## Draft IEEE P2800 Working Group Meeting Minutes, 9/25/19 – 9/26/19

IEEE P2800 Standard for Interconnection and Interoperability of Inverter-Based Resources  
Interconnecting with Associated Transmission Electric Power Systems

Existing Figure 1.

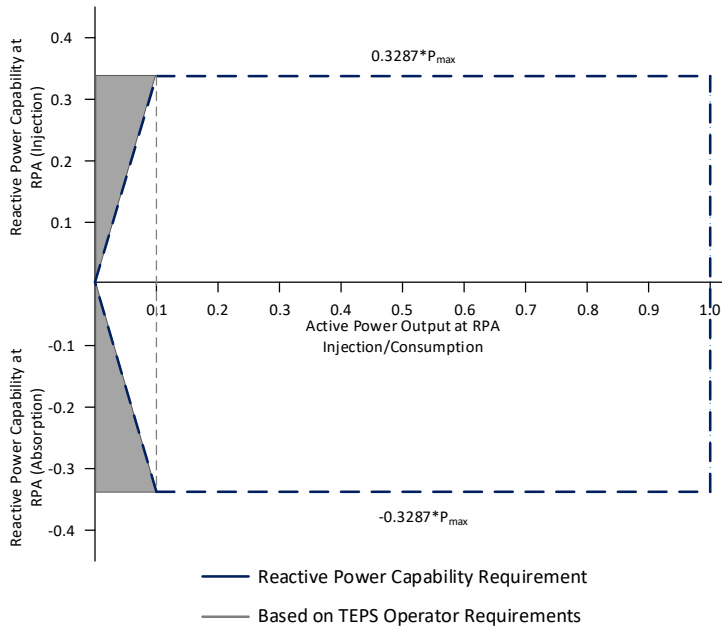
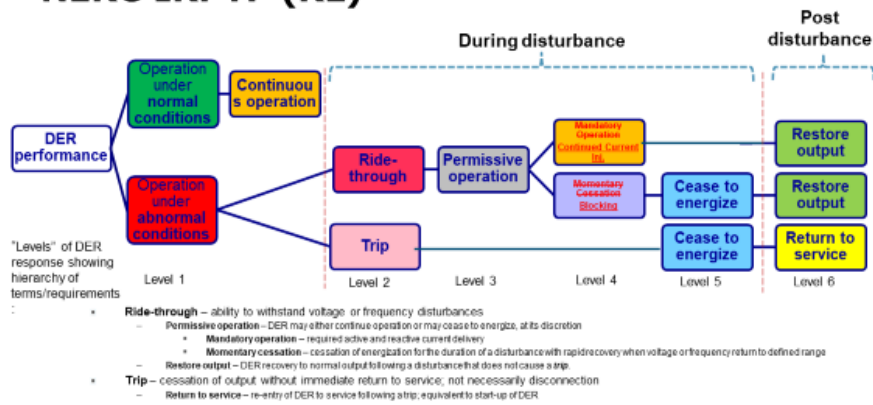
The main discussion point was regarding the reactive power requirements depicted in figure 1 of draft 1. The question posed to the WG for feedback was whether the reactive power requirements should be the same across all technologies (in which case it would likely result in the alternative figure) or if exceptions should be allowed for type 3 wind such that we do not limit the requirements to the technical limitations of type 3 wind (existing figure). An informal vote was taken which showed a slight preference for the alternative figure. [Link](#). Later in the meeting, a general vote was taken which showed a large preference for setting ambitious technical minimum requirements adding exceptions for certain technologies as needed. [Link](#). Taking this direction, SG 4 will continue with the existing figure 1 in draft 1.
